## **PLAN REVIEW SHEET**

2017-202

Sinacori Builders, LLC

Bus stop pad detail

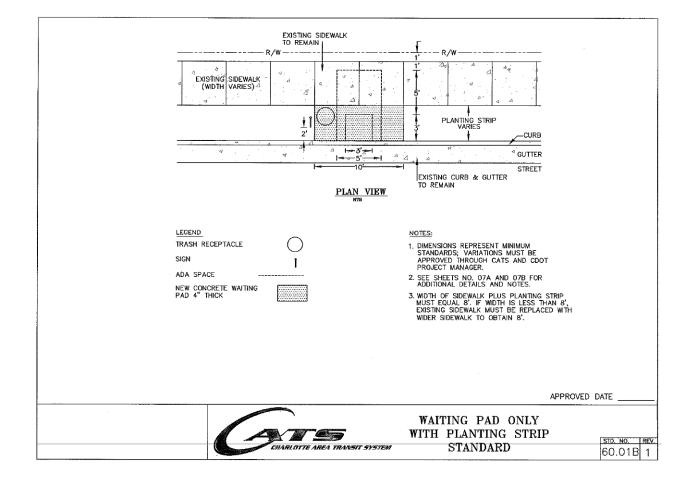
This site is along an existing bus route. The Petitioner is requested to provide and construct a new waiting pad for a relocated stop on Providence Road along this site's frontage.

Below is an image of the standard detail (60.01B) for the requested bus stop pad. Permanent easement is requested, where dimensions exceed existing or proposed right-of-way limits.
